I. M. C. Zoological Park, Chhatbir, Punjab

1. Pheasantry to be redone after demolition

Subject: **Minutes of the 48th meeting of the Expert Group on Zoo Designing of Central Zoo Authority held on 3rd February, 2014.**

PROPOSED PHESANTRY AT CHHATBIR ZOO

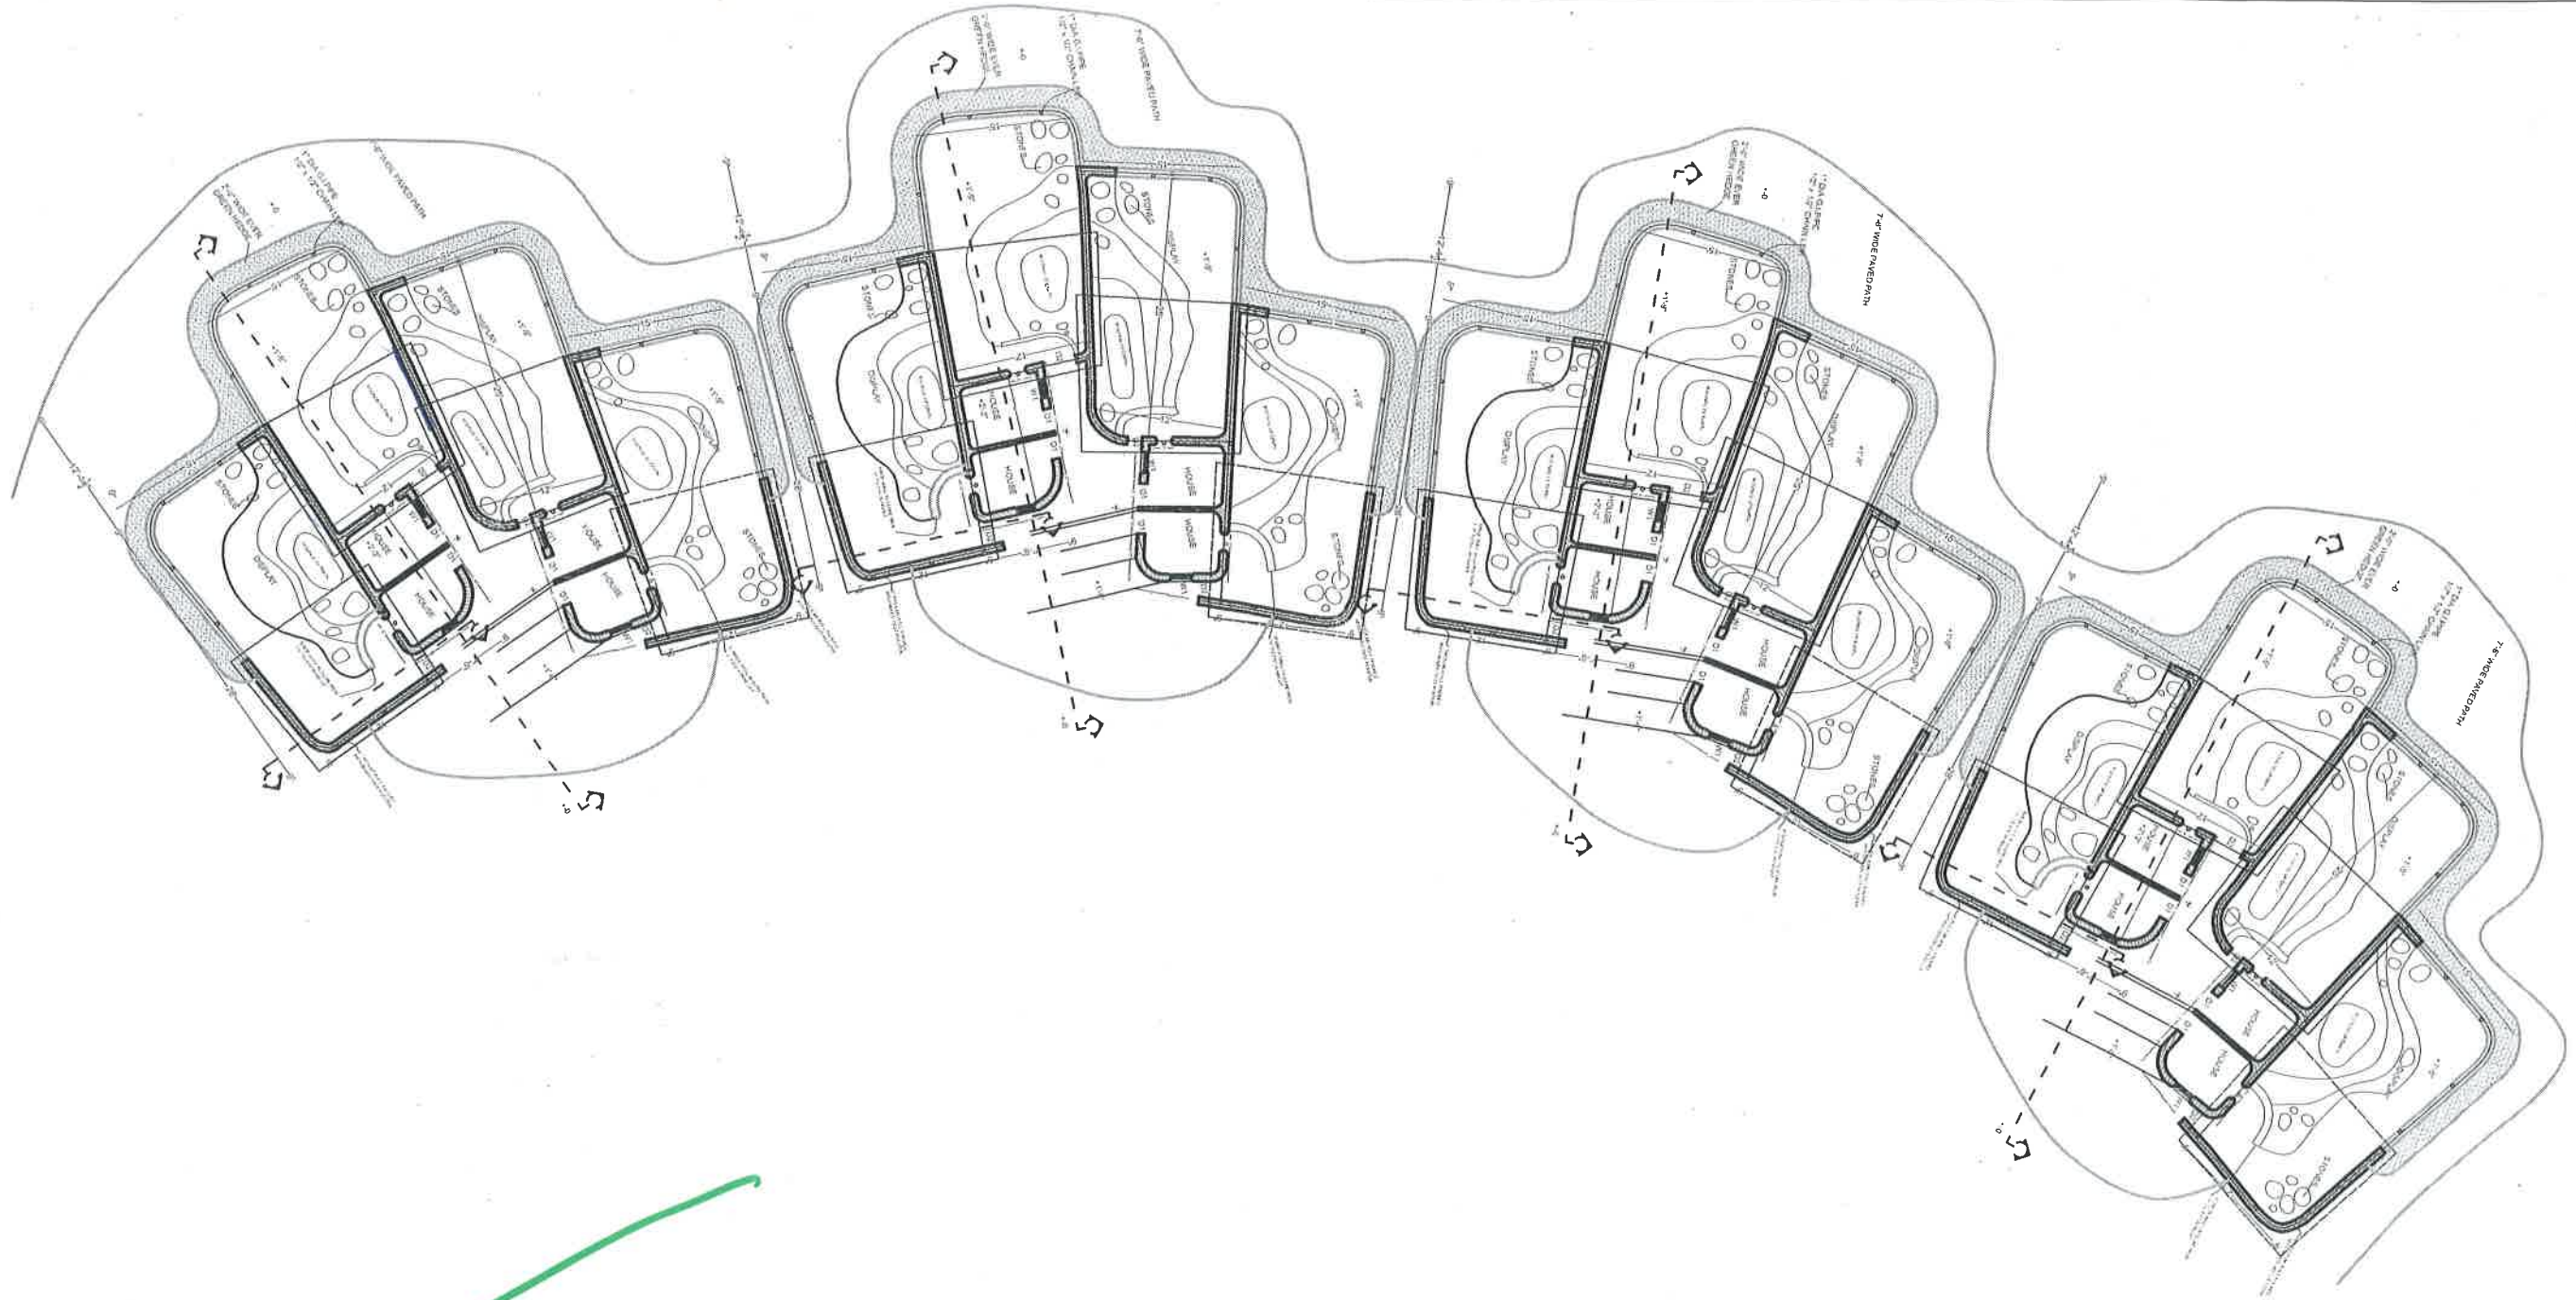
- a) The size of the each aviary in Pheasantry should be increased to 80 mt. (10 mt depth, 8 mt. width).
- b) It should be ensure that the visitors to see one species at a time, therefore green buffer at the corners should be provided.
- c) The wall of the houses should be comflauged appropriately.

PROPOSED PHESANTRY SINGLE UNIT

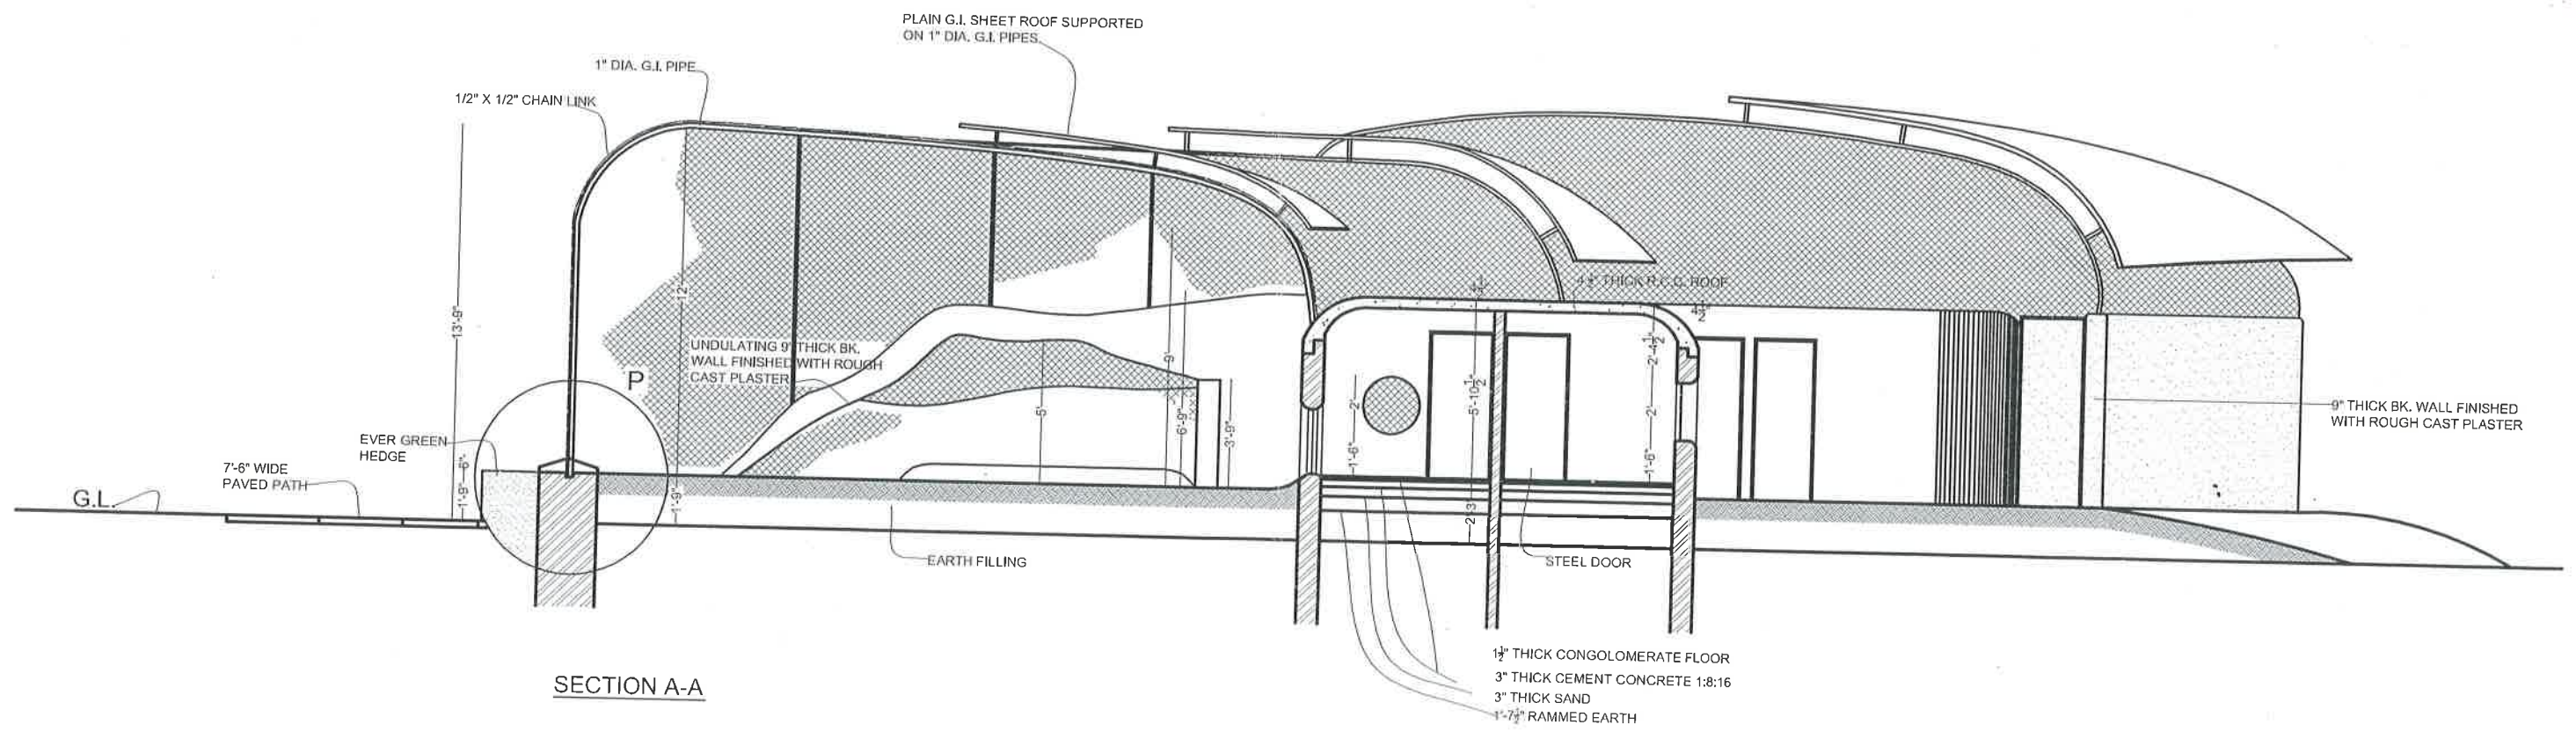
Walls should be Camry/Alloy
